Department of Primary Industries and Regional Development – Fisheries

8th November 2024

We refer to your letter dated 22 October 2024. We have reviewed the letter and discussed its contents with our Planner GSA, Marina Designer IMC and our Marine Ecologist Marine Pollution Research. Please find below some comments which address the items raised in your letter:

North Harbour Marina

Figure 2: Proposed new berths including 3 x 9m boats in angled berths on western arm (increased offset from seagrass bed – see purple hatched area)

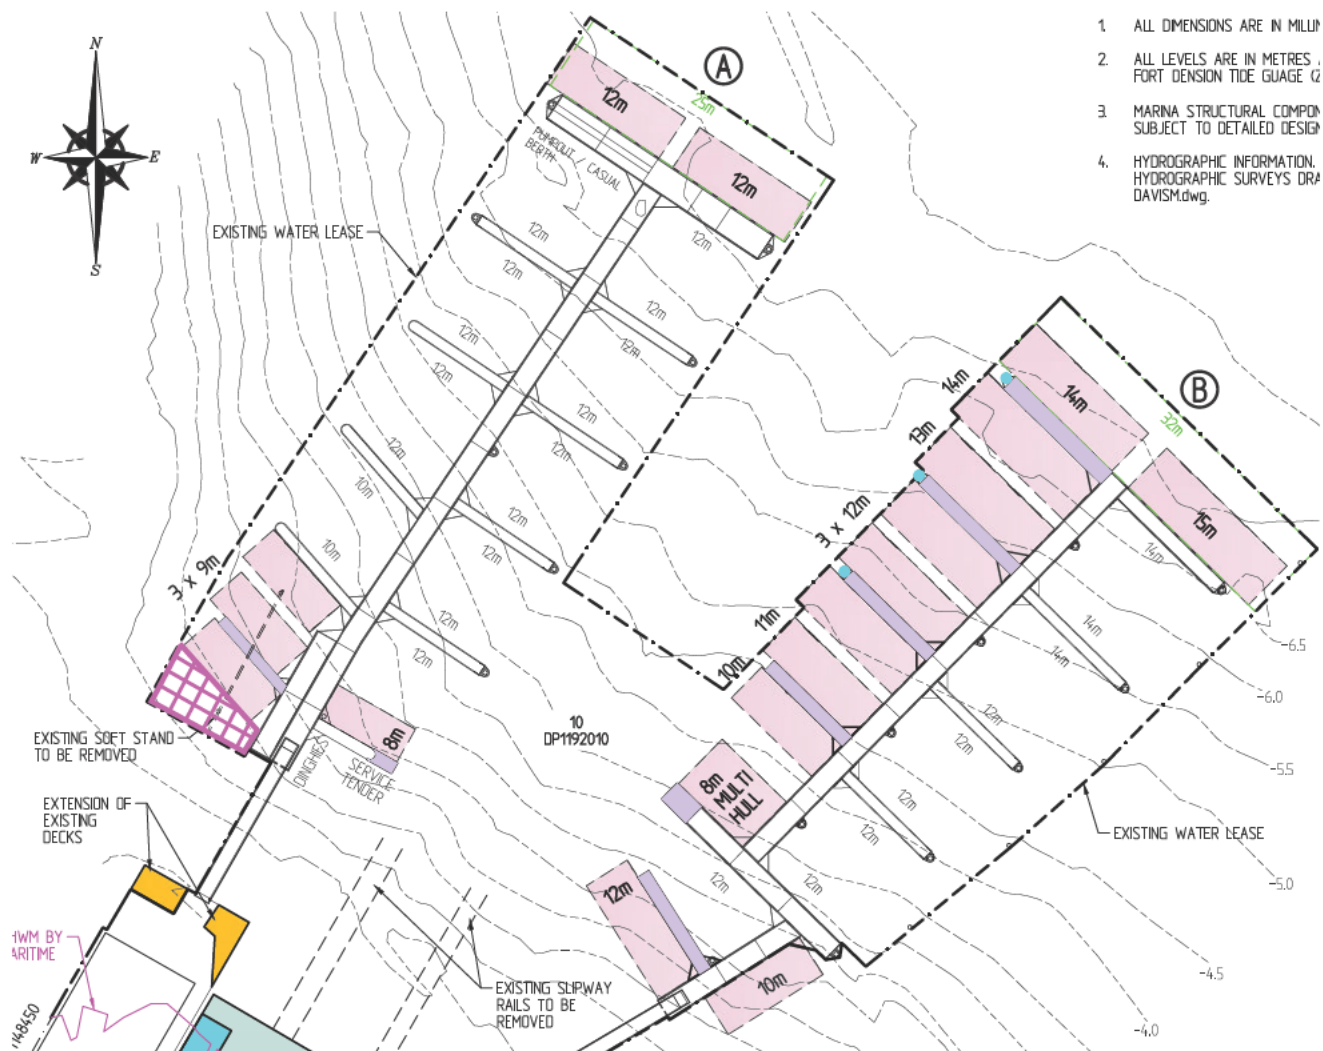
- The proposed berths on the western arm would occupy an area already approved for 4 x 10m yachts with deep keels (see Figure 1), the proposed berths are further offset away from the zostera seagrass bed and only 3 x 9m vessels are proposed instead of the existing 4 x10. These berths are angled away from the seagrass bed (see Figure 2). The impact of these berths can be further reduced by the proposed condition #1 below.

- **Proposed Condition #1:** The 9m berth closest to shore on the western arm must not be used by a sailing boat or a boat with a fixed propeller of any kind. It must only be used by a boat with an adjustable outboard motor.

Proposed Condition #1 (Updated): *The 9m berth closest to shore on the western arm must not be used by a sailing boat or a boat with a fixed propeller of any kind, it must only be used by a boat with an adjustable outboard motor. In addition to maintain sufficient under keel clearance of greater than 300mm as per Australian Standard 3692 the 3 x 9m berths on the western arm are to be limited to 0.75m, 1m and 1.5m draft vessels (south to north). This condition will enable 500mm minimum clearance at 0m Z.F.D.T.G which is greater than the Australian Standard requires.*
